Nkk Knitwear Ltd. (Extension)

KUTUBAIL, FATULLAH, NARAYANGANJ, DHAKA, Bangladesh
(23.642571, 90.487552)
5 November 2024

Building-3 (New Production Building) is an eight-storied (B+G+7) RC building with an underground fire pump room and water reservoir.

Column schedule in as-built drawing

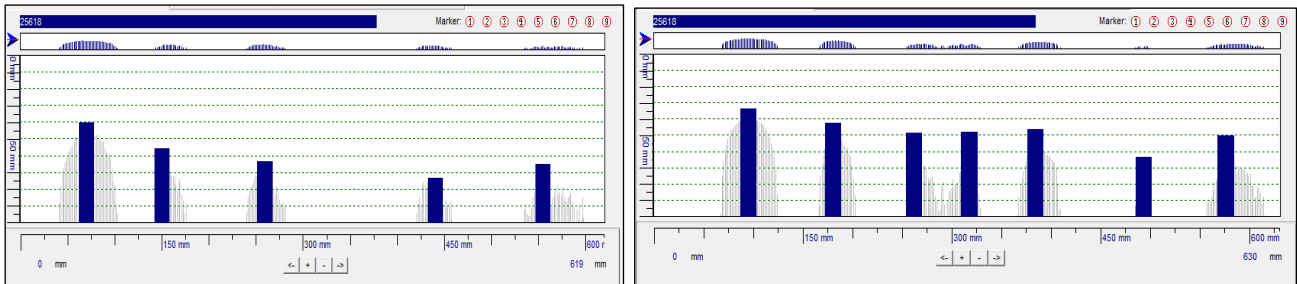
A total of 20 nos of rebars were found from the ferro-scan

Description: During inspection, the number of rebars was found mismatched for the C1 column at grid B/2 on the 4th floor. In the as-built drawing, the total number of rebar has been provided 24 nos (7X7). But, from the ferro-scanning, total 20 nos (5X7) of the re-bar was found. Building engineer is required to survey the whole structure and prepare accurate as-built drawings.
